LB Note: 24.02.2021
This drawing has been updated as part of the Section 96a application. Please see adjacent notes for plan updates.

Land at Coleshill Street
Miles Platting

Drawing number: 3547A - LEV - 00 - 03 - DR - A - 1443
Rev: P3

Plot E_Proposed Third Floor Plan

1 Plot E_Third Floor Plan
1 : 200

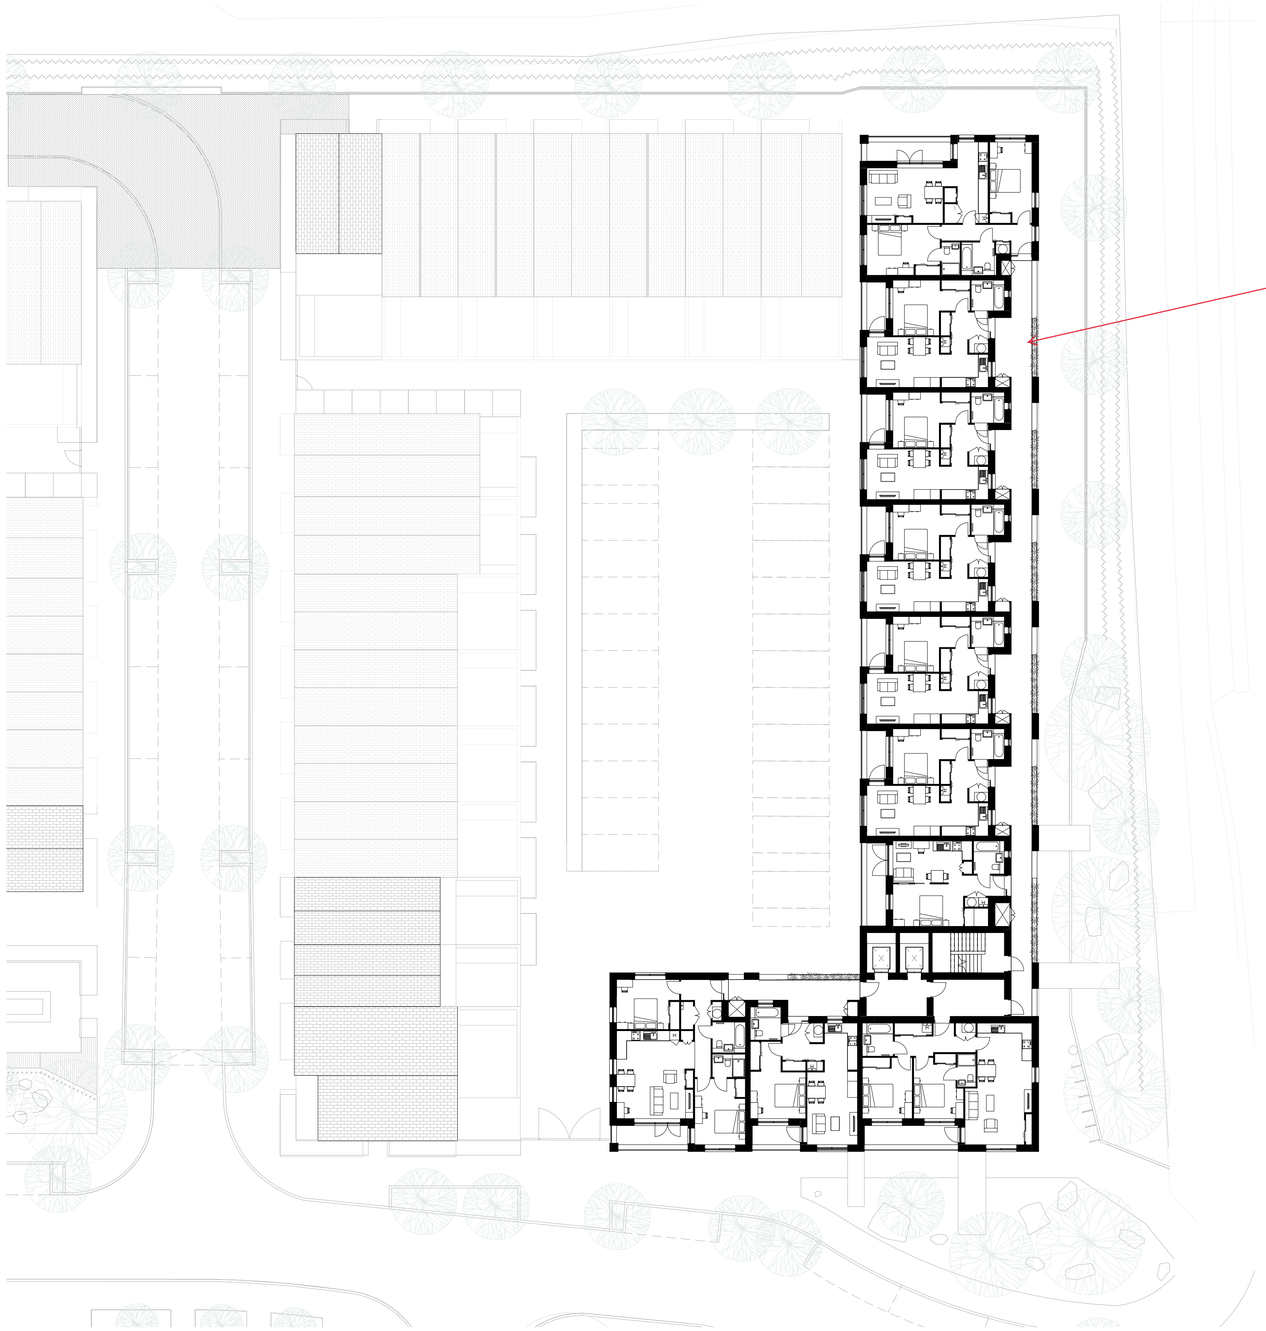
Reduction in walkway and apartment widths by 112.5mm. All apartment internal areas remain over MRQG guidance.
